## Project Name EXISTING CONDITION PHOTOGRAPHS

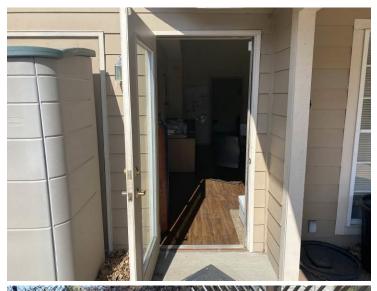
ORIGINAL Move sink over 8 inches

Improper office signage

Corridor door should be removed (18 inches minimum pull front approach)

Broken cabinets, no legroom under sink, load center too high

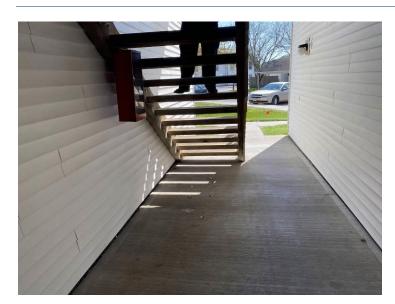
Aisle into kitchen is 28.5 inches

Light switch at 46

18 inches required front pull approach
